RE: 071825_VA Credit Union, Blacksburg, VA - BMEP 1st rev

Virginia Credit Union Branch renovation 202 N. Main St.

A. Comments & Responses

Itemized below are responses to the review comments for project #071825, dated 8/13/25. Replies to comments are listed in the order in which they appear within the reviewed and marked up PDF "071825_VA Credit Union, Blacksburg, VA - BMEP 1st rev" from top to bottom of each sheet.

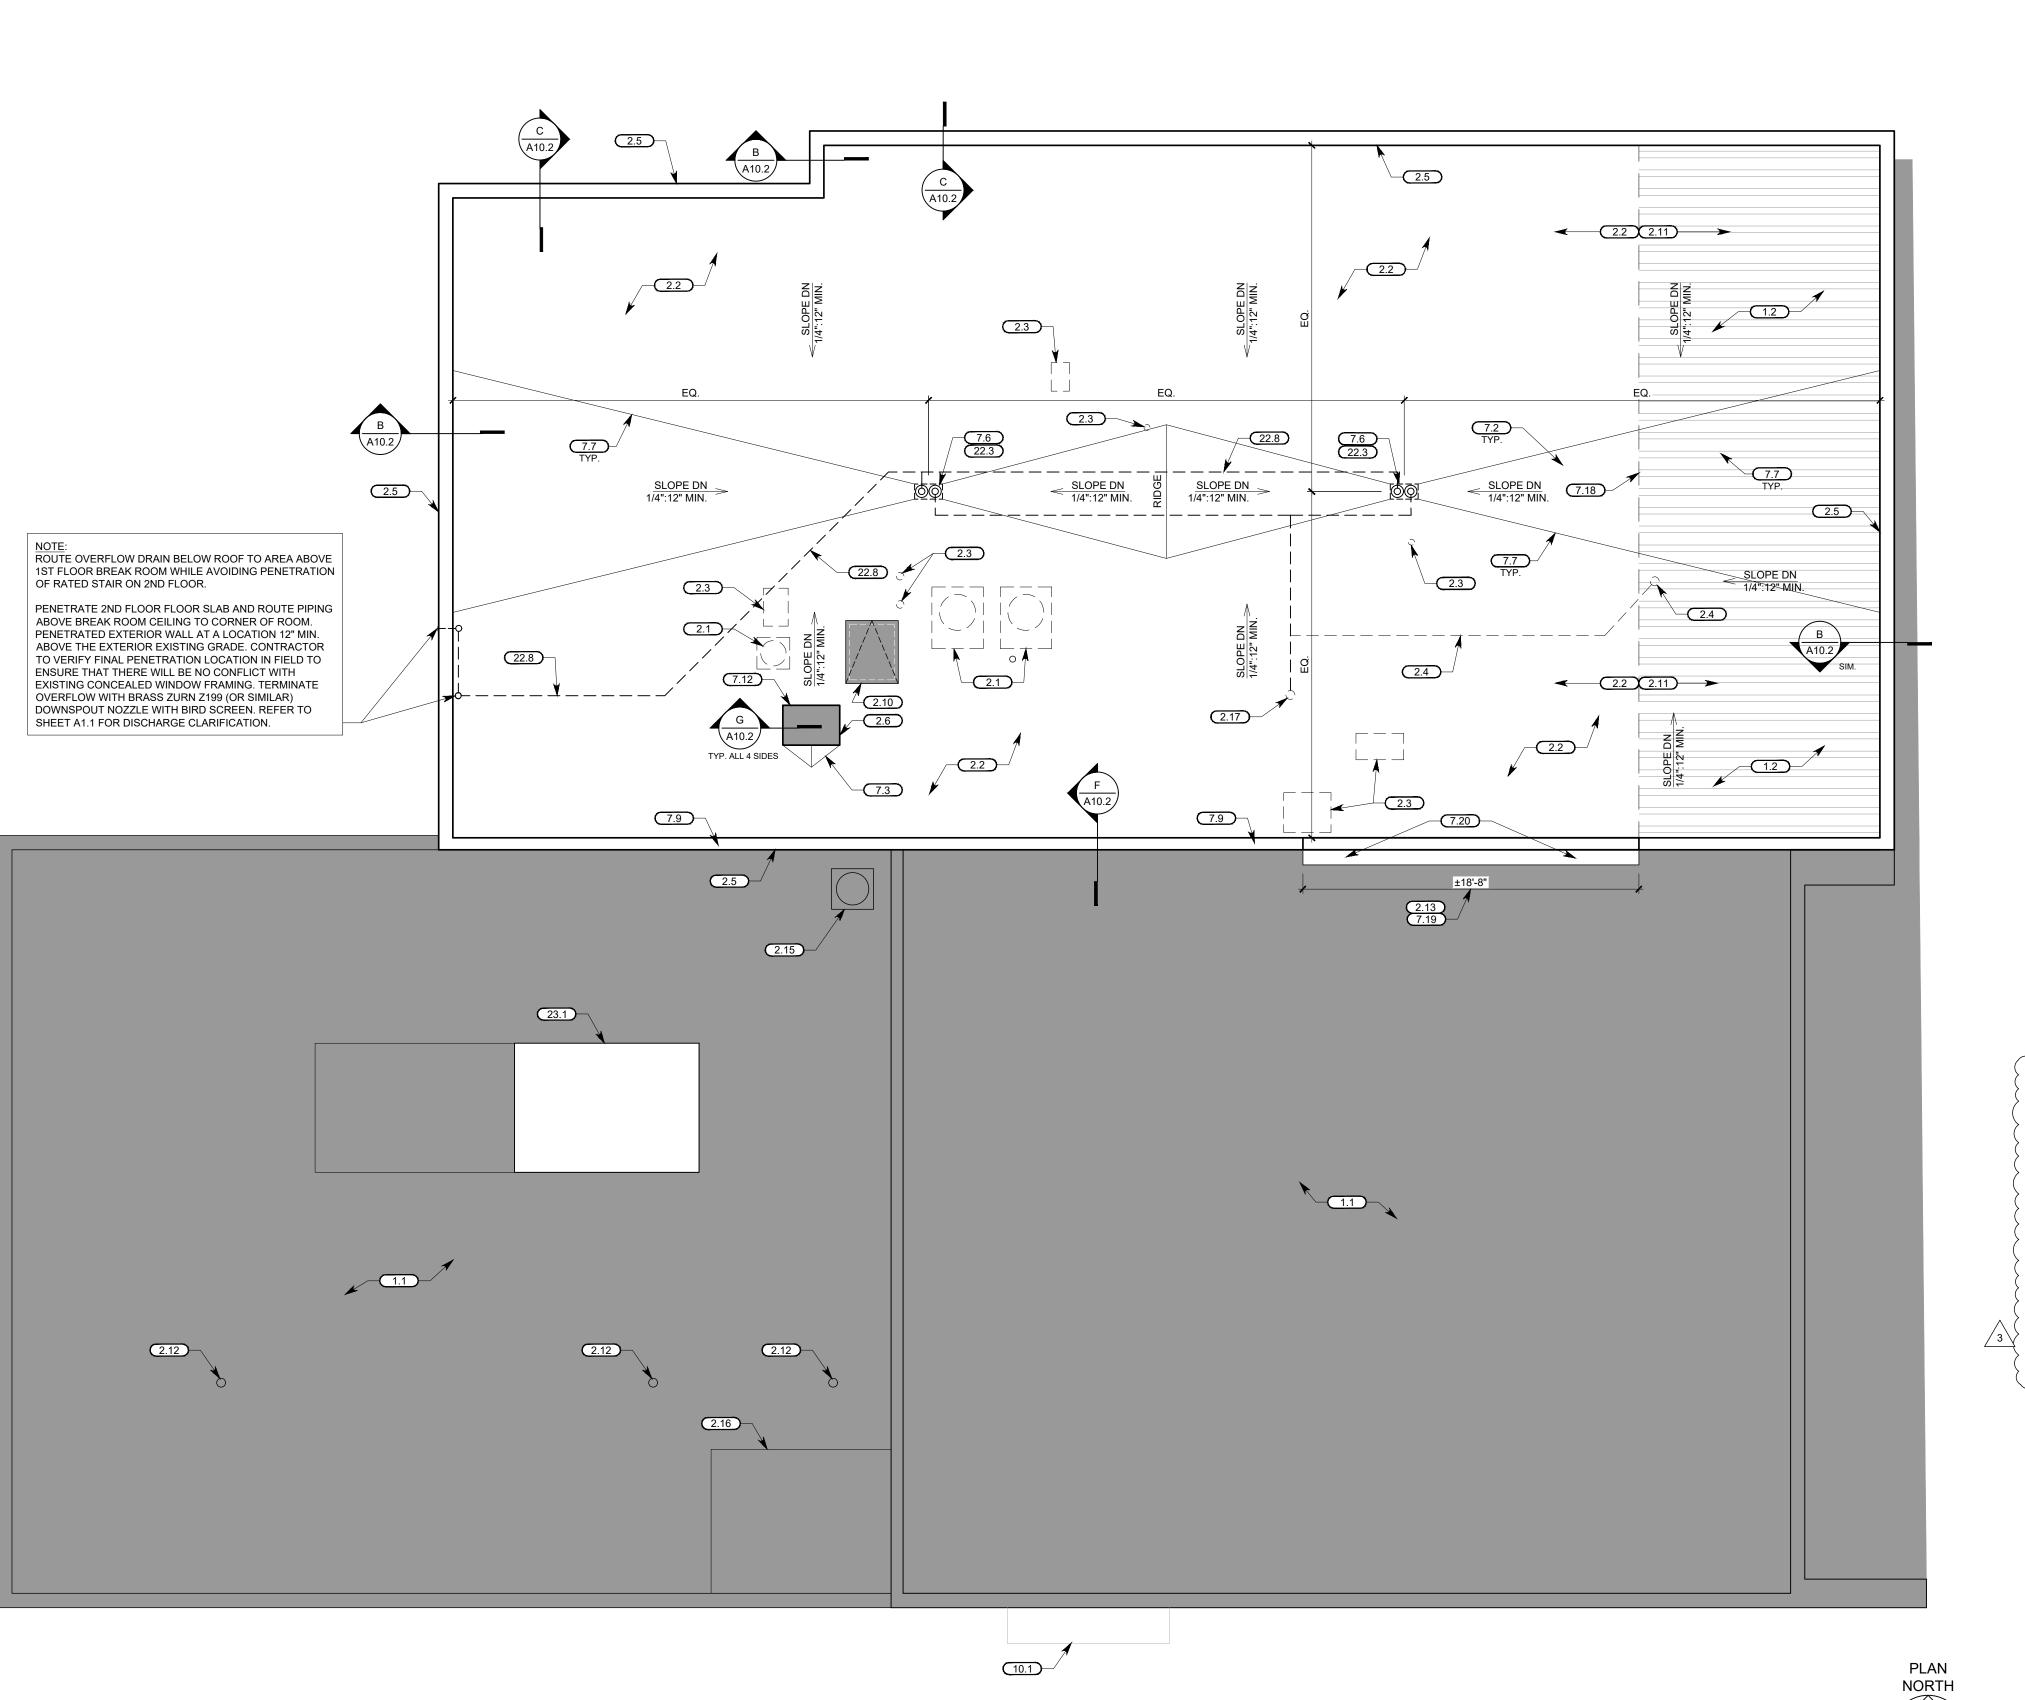
6. Reviewer's Comment (Sheet A10.1 Coded Note 23.1):

Please provide a copy of the engineering analysis to support this statement.

7. Reviewer's Comment (Sheet A10.1 Building Insulation Schedule):

Please review VEBC 601.4. Any building envelope cavities or new insulation must meet the minimum requirements of the VEBC and VECC as referenced.

Response:

Please see attached signed and sealed formal calculations from Structural Engineer providing their analysis of this condition.

Response:

Sheet A10.1 has been revised with updated roof insulation information. Additionally, a boxed note indicating insulation requirements of opaque walls added to the A1.1 sheet.

- A. Building Insulation Schedule
 - 1. Removed Building Insulation Schedule and Building insulation General Notes.
 - 2. Added Roof Insulation General Notes to clarify roof insulation information, installation, and energy code compliance.
- B. Coded Notes: Removed reference to insulation type (I-2) from notes 7.1 & 7.2.

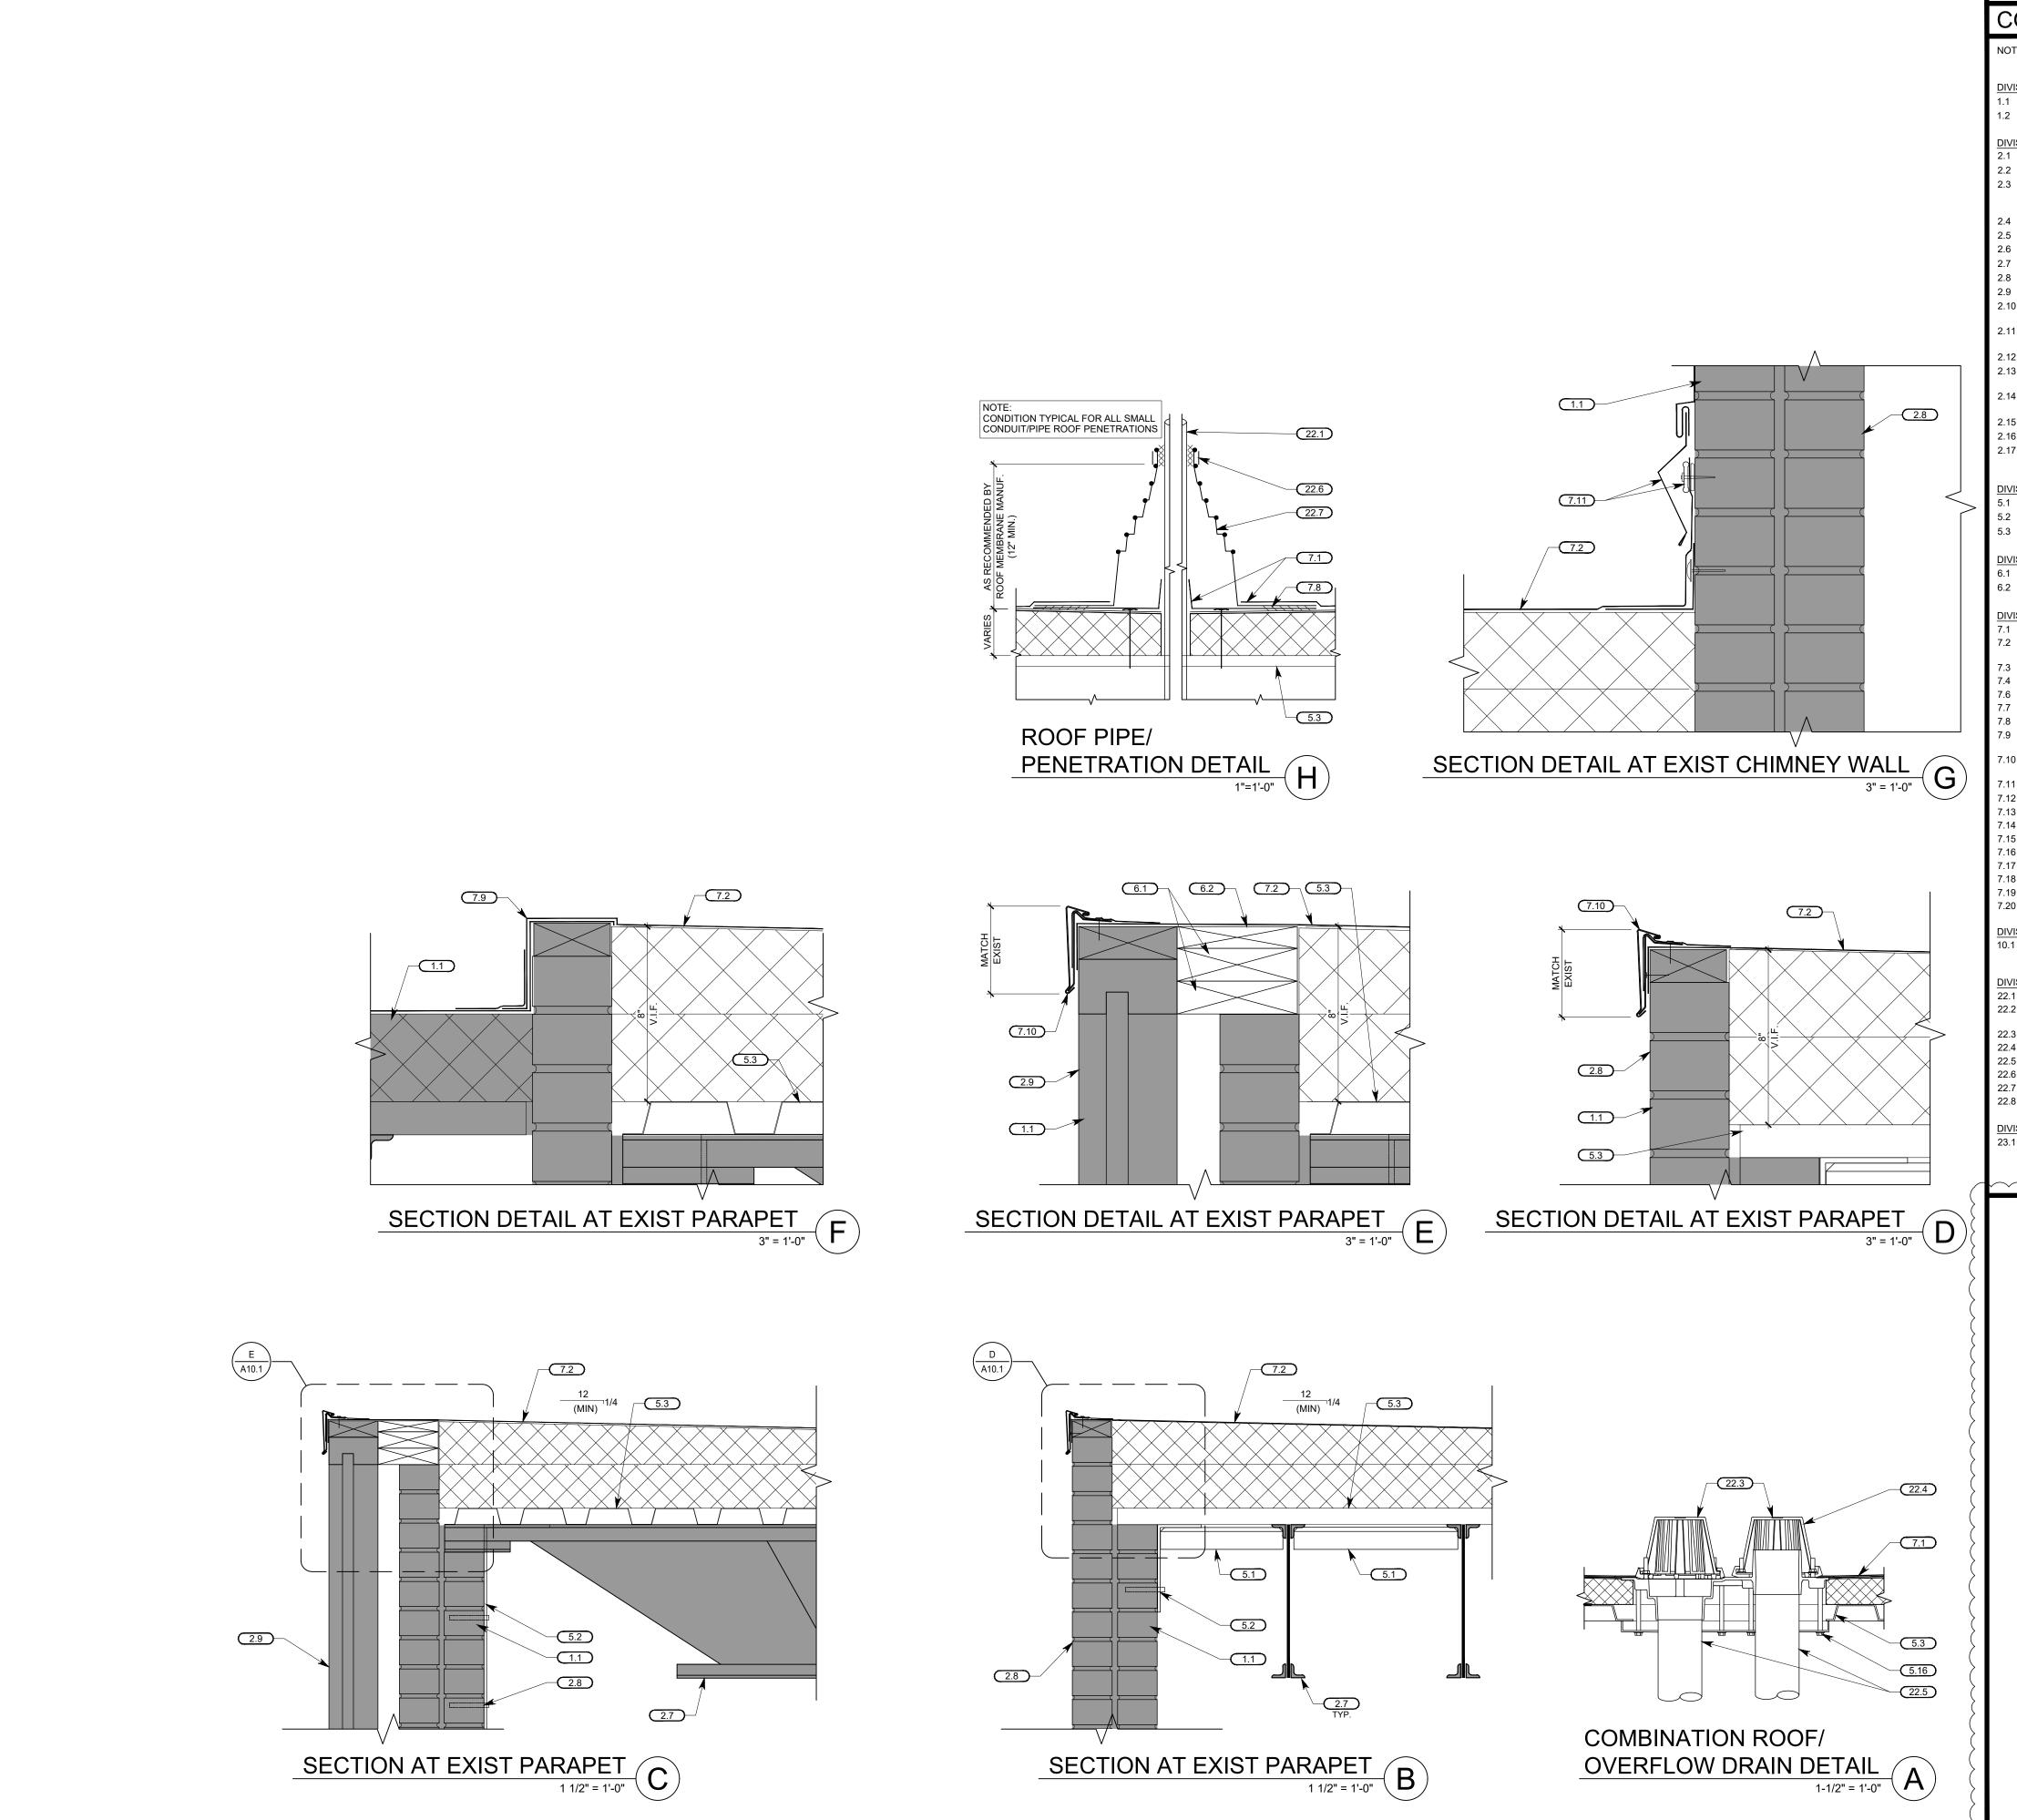
8. Reviewer's Comment (Sheet A10.2):

All of this data is duplicated information, recommend not duplicating data

Response:

Acknowledged and removed, see attached revised Sheet A10.2

- A. Removed duplicated information and added box-note in its place.
- B. Coded Notes: Removed reference to insulation type (I-2) from coded notes 7.1 & 7.2.
